RESPONSE TO REQUEST FOR ADDITIONAL INFORMATION

APR1400 Design Certification

Docket No. 52-046

RAI No.: 287-8272

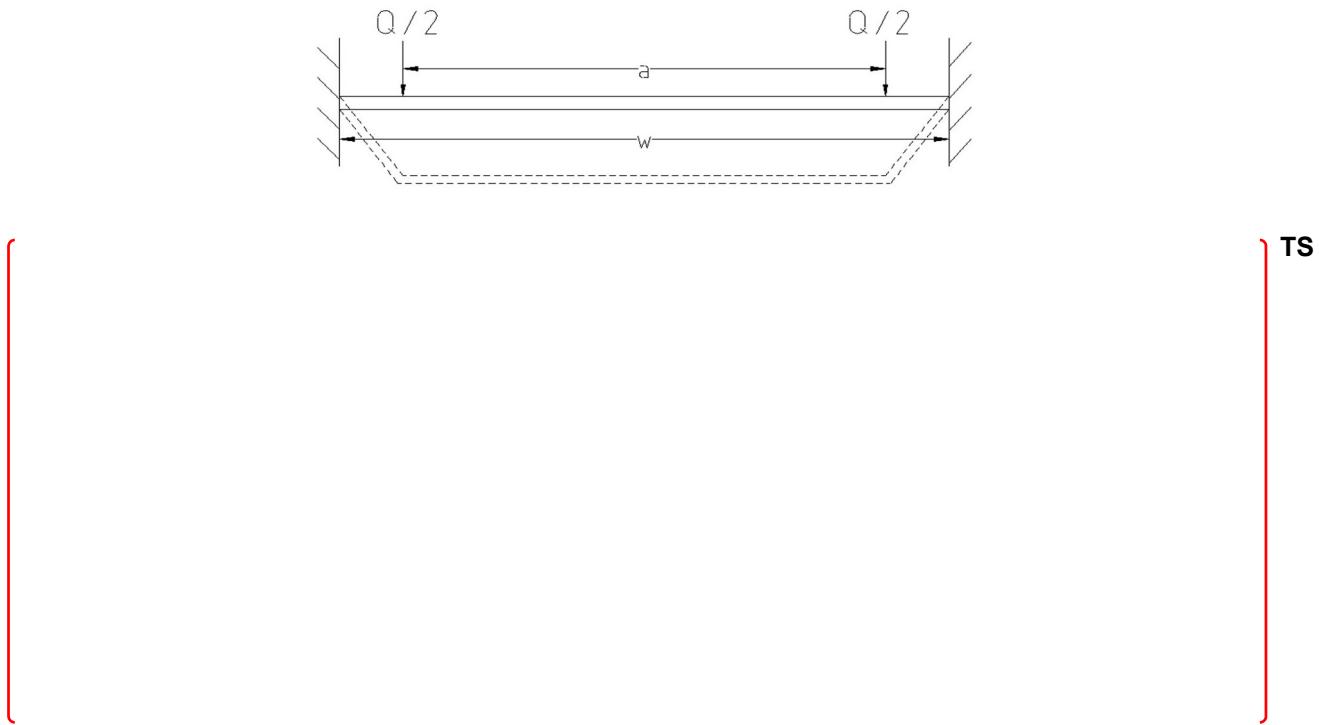
1. The 10 CFR Part 50, Appendix A, General Design Criteria (GDC) 1, 2, 4, 5, 63, and 10CFR 52.80 (a) provide the regulatory requirements for the design of the new and spent fuel storage facilities. Standard Review Plan (SRP) Sections 9.1.2 and 3.8.4, Appendix D describes specific SRP acceptance criteria for the review of the fuel racks that are acceptable to meet the relevant requirements of the Commission's regulations identified above. The SRP 3.8.4 Appendix D section I (3), "Seismic and Impact Loads" requires that "Because of gaps between fuel assemblies and the walls of the guide tubes, additional loads will be generated by the impact of fuel assemblies during a postulated seismic excitation. Additional loads resulting from this impact effect may be determined by estimating the kinetic energy of the fuel assembly. The maximum velocity of the fuel assembly may be estimated to be the spectral velocity associated with the natural frequency of the submerged fuel assembly. Loads thus generated should be considered for local as well as overall effects on the walls of the rack, the supporting framework. It should be demonstrated that the consequent loads on the fuel assembly do not lead to damage of the fuel." In order for the staff to perform its safety evaluation of the racks for impact loads, the applicant in accordance with SRP 3.8.4 Appendix D I.3, is requested to provide the details of how the additional loads due to the impact of fuel assemblies during a postulated seismic excitation are computed and how these loads are considered in the analysis and design of the walls of the rack and supporting framework and demonstrating the structural integrity of the fuel.

The additional loads due to the impact of fuel assemblies during a postulated seismic excitation are computed from the reaction loads on the spring-mass elements of the fuel assembly-to-cell wall by dynamic analysis. The maximum impact load of the fuel support grid is calculated by dividing the maximum impact load (25,000 lbf) per cell by the number of spacer grids (11 ea), which is shown on the Table 3-10 in the report APR1400-H-N-NR-14012-P. All the fuel assemblies in each storage rack module are modeled as one beam of of

which the mass equals the sum of the masses of all the fuel assemblies in a rack module. Because the fuel assemblies in a rack module are modeled together, all fuel assemblies move simultaneously in the same direction at the same time. This assumption included in this model brings about a larger impact on the rack module than the actual movement and results in conservative loads on the storage rack. The fuel assembly is modeled with only three nodes so that the calculated impact loads on the nodes will be larger than the actual value, because the fuel assembly actually has spacer grids (11 ea).

The design check of the cell wall for the fuel assembly impact load is performed by comparing the maximum calculated impact load obtained from the computer code ANSYS with the limit load for an individual cell wall.

The limit load for an individual cell wall is determined on a beam strip (the width of a single cell), which is subject to impact loads simulating two corners of a fuel assembly. The collapse load on structure of the panel shape can be explained by the collapse due to bending. The impact of fuel-to-cell wall is assumed to occur over a vertical dimension along the cell wall.

The limit load for an individual cell wall calculated using the above formula is 10,660 lbf. It is much larger than the maximum impact load of fuel support grid (2,273 lbf) given in Table 3-10 in the report APR1400-H-N-NR-14012-P. Therefore, the stresses in the cell membrane are acceptable for the postulated fuel impact.

Deformed Shape of the Rack Baseplate

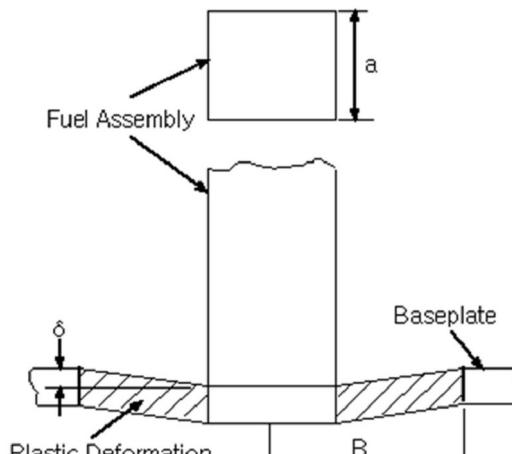
1. The 10 CFR Part 50, Appendix A, General Design Criteria (GDC) 1, 2, 4, 5, 63, and 10CFR 52.80 (a) provide the regulatory requirements for the design of the new and spent fuel storage facilities. Standard Review Plan (SRP) Sections 9.1.2 and 3.8.4, Appendix D describes specific SRP acceptance criteria for the review of the fuel racks that are acceptable to meet the relevant requirements of the Commission's regulations identified above. In DCD Tier 2, Section 9.1.2.2.3, "New and Spent Fuel Storage Rack Design", the applicant stated that "The dynamic and stress analyses are performed as described in report APR1400-H-N-NR-14012-P & NP". In the report APR1400-H-N-NR-14012-P, Rev.0, Section 4.1 "Description of Mechanical Accident", the applicant considered a drop of fuel assembly in an interior cell away from the support pedestal for one of the 'Straight Deep Drops' scenario. The applicant is requested to provide specific location(s) of the drop on the rack base plate that were considered to maximize the deformation of the rack base plate and whether it also considered a deep drop into a cell along the perimeter and half way between the supports. It is not clear from the description whether the rack baseplate evaluation due to fuel impact assumed that other fuel assemblies are in place when a fuel assembly drops through an empty cell. A full load of fuel assemblies may introduce progressive deformation of the baseplate after a fuel assembly impacts the rack baseplate. The maximum downward deformation of the baseplate may be significant enough to initiate a progressive deformation. Therefore, the applicant is also requested to provide (1) the technical basis and justification for not considering all other fuel assemblies in place when a fuel assembly drops through an empty cell and (2) the design basis for the rack baseplate including the basis for determining the most critical locations of the fuel assembly drop.

The applicant is requested to identify any proposed changes to and provide a mark-up of Subsections in the DCD Tier 2 and the report APR1400-H-N-NR-14012-P, Rev.0, as appropriate.

- (1) The calculated deflection of the baseplate due to the deep drop conservatively ignores the reinforcing effect of the cell-to-baseplate welds. The strength provided by the cell-to-baseplate weld reinforcement would offset the added static load of the fuel assemblies. Therefore, all other fuel assemblies in place is not considered when a fuel assembly drops through an empty cell.
- (2) When a fuel assembly drops to the baseplate of a rack, the baseplate must not experience gross failure (i.e., puncture), and the deformed baseplate must not impact the pool liner. In the deep drop analysis (away from the pedestal), a specific location on the rack baseplate was not considered because the maximum deformation of the rack baseplate is calculated without a support under the rack baseplate.

The figure below shows the final deformed shape of the baseplate considered in deep drop analysis.
